# Cassidy Arch Canyon -- Anchor Evaluation -- June 6, 2016

## **Site Notes – First Rappel anchor at Cassidy Arch**

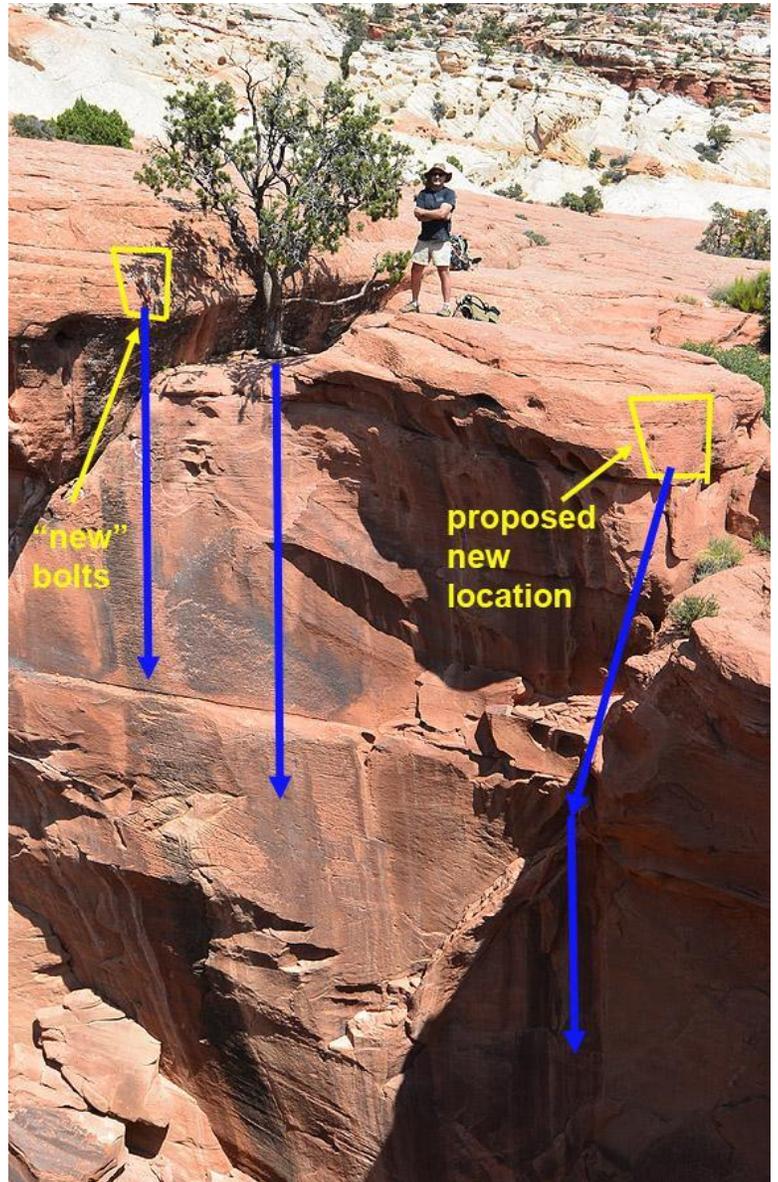
- A. We examined the area between the tree and the new two-bolt anchor, and it would be possible to move the anchor to a new location, about half way between the bolts and the tree. This anchor could be rigged from the front side of the tree, and would be easier to initiate the rappel, though it would still require stepping around the tree to get started. An additional complication is that at the most straightforward place to put new bolts, the rock is hollow, so the bolts would have to be put a foot or so higher – not a significant problem but one the bolt installer would need to be aware of. To an experienced installer, this would be an easily found and solved problem.

- B. We examined a ledge and wall about 8 feet from the tree ledge. This location offers a smooth wall of robust rock and a clean line of rappel, with easy access to the anchor and an easy start to the rappel. The location would not be seen by hiking visitors from above and behind the arch, the most popular viewing location. An anchor here would be visible to visitors that walk onto the arch but would be far enough away from them to not be “in their face”. If the anchor was painted to color-match the rock, many visitors would not notice it.

Other places around the rim of the hole do not provide any reasonable alternatives. In most places, there are no features to work with – the rock mostly forms a 90-degree edge. Any anchor places other than A) or B) would be atop the rim and conspicuous to all visitors, plus would have an awkward, inconvenient and possibly dangerous rappel start.

Our recommendation is to place a two-bolt anchor at position B and remove the existing bolts from behind the tree. A de-galvanized chain should be used to rig the anchor, and the chain, bolt heads and hangers painted to match the rock color.

While a new anchor could be placed behind the tree, continued visitor contact with the tree would kill it in the one to three year time frame.
